Access Compliance Report

Public Rights-of-Way

(Curb Ramps)

Intersection ID: 49101	Main Street: PROSPERITY_CROSSING_DR	Cross Street: DOCIA_CROSSING_RD	Location: SW
ADA ID: 1AF9B8045EFF	Ramp Type: Perp	Initial Pass/Fail: Pass	Overall Compliance: No
Severity Score: 0			
Codes/Mitigation Info/Possible Solution		Field Measurements/Component Compliance

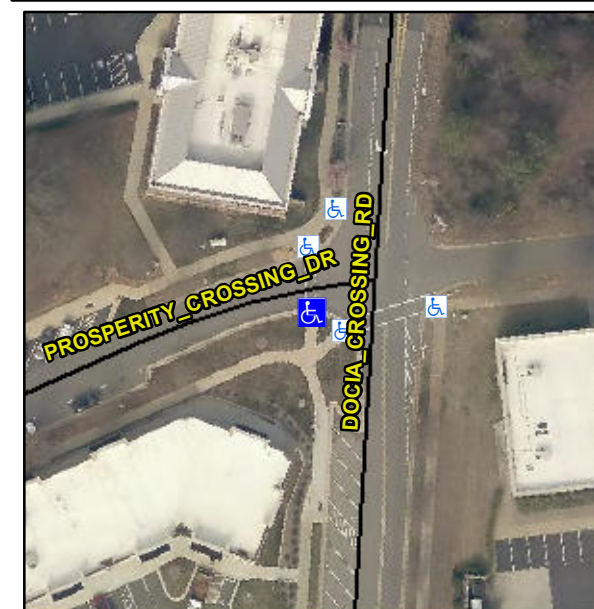
Remove & Replace Detectable Warning System. Remove & Replace Gutter.

R305.2, R304.5.3
